Remarks/Arguments

Reply to Office Action dated November 1, 2005
Application Serial No. 10/677,528
Amendment dated February 1, 2006

FIG. 1

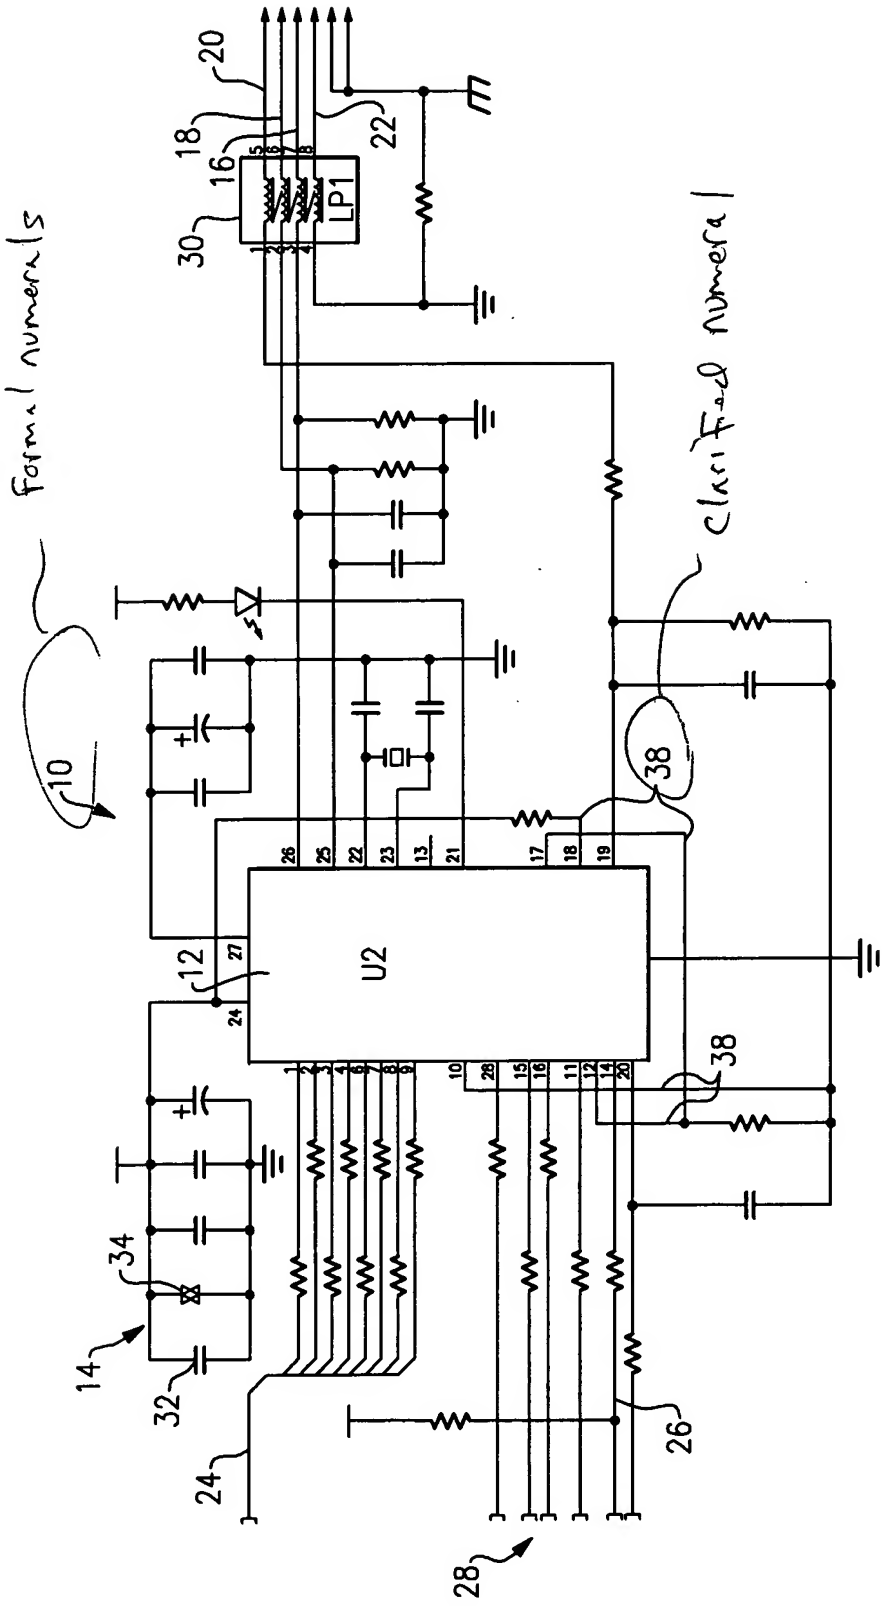
In the Action, the Examiner objected to the drawings because a reference numeral was unclear and not mentioned in the specification. The Examiner objected to claim 1 as including an acronym. The Examiner rejected claims 1-3, 5-6, 8-10, and 12 as unpatentable under 35 U.S.C. § 103 as obvious over U.S. Patent No. 6,937,454 to Mikolajczak et al. ("*Mikolajczak*") in view of U.S. Patent No. 6,101,076 to Tsai et al. ("*Tsai*"). Claims 4 and 11 were rejected as unpatentable under 35 U.S.C. § 103 as obvious over *Mikolajczak* and *Tsai* in further view of U.S. Patent No. 4,571,656 to Ruckman ("*Ruckman*"). Claim 7 was rejected as unpatentable under 35 U.S.C. § 103 as obvious over *Mikolajczak* and *Tsai* in further view of U.S. Patent No. 6,452,269 to Ohbayashi ("*Ohbayashi*") and U.S. Patent No. 5,956,158 to Pinzarrone et al. ("*Pinzarrone*").

Applicant has submitted amended drawings complying with the Examiner's request for formal drawings. Applicant has also amended the specification to correct a typographical error in the reference to numeral 38 of Fig. 1.

The attached sheets of drawings includes changes to Fig. 1 and 2. These sheets, which include Figs. 1 and 2, replace the original sheets including Figs. 1 and 2. The drawing figures have been amended to clearly show the reference numeral at the bottom of Fig. 1 and comply with regulations regarding formal drawings.
